City of Portsmouth
Department of Public Works

Bid Proposal #30-06
Shoreline Repairs Prescott Park and Four Tree Island
Addendum #1
January 27, 2006

PRESCOTT PARK SITE PLAN

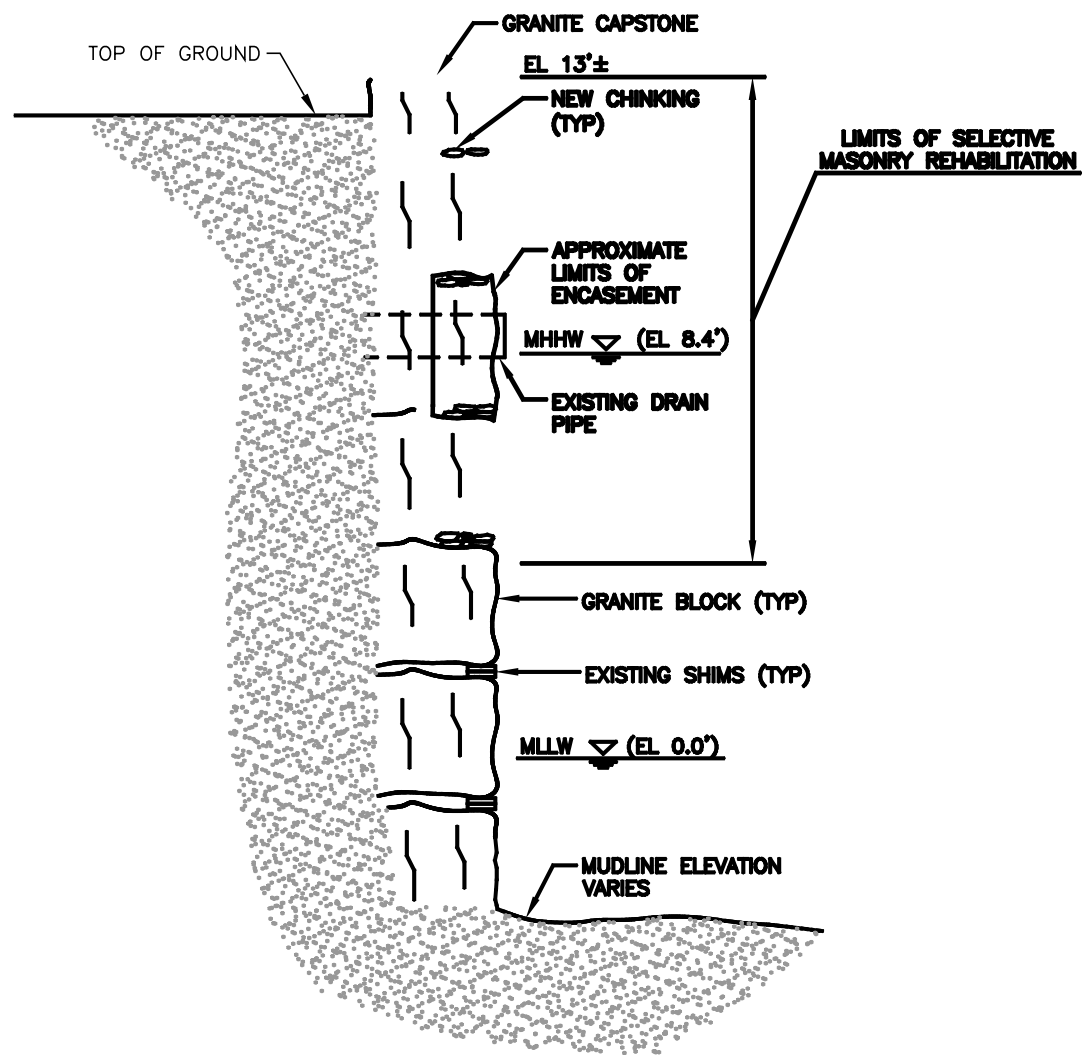
Alternate #1 Drain Line Modifications:

There is an old drain line extending into the river between T-Head Pier and the Existing Pier. This pipe consists of small sections of 30" Cast Iron pipe and is essentially lying on the river bottom. The proposed modifications consist of the following:

1. Excavate old 30" CI drain pipe from where it exits the ground at approximately mid-tide level to its termination near the end of the existing pier. (Approximately 100 LF)
2. This new termination shall be slip-lined with a 27" PVC pipe and mortared in place for a minimum length of 10'. Contractor to confirm the pipe size.
3. Rip Rap Class A shall be placed around the new out-fall to stabilize the structure in accordance with the Standard Details Sheet 2 of 3 entitled Prescott Park Sections.
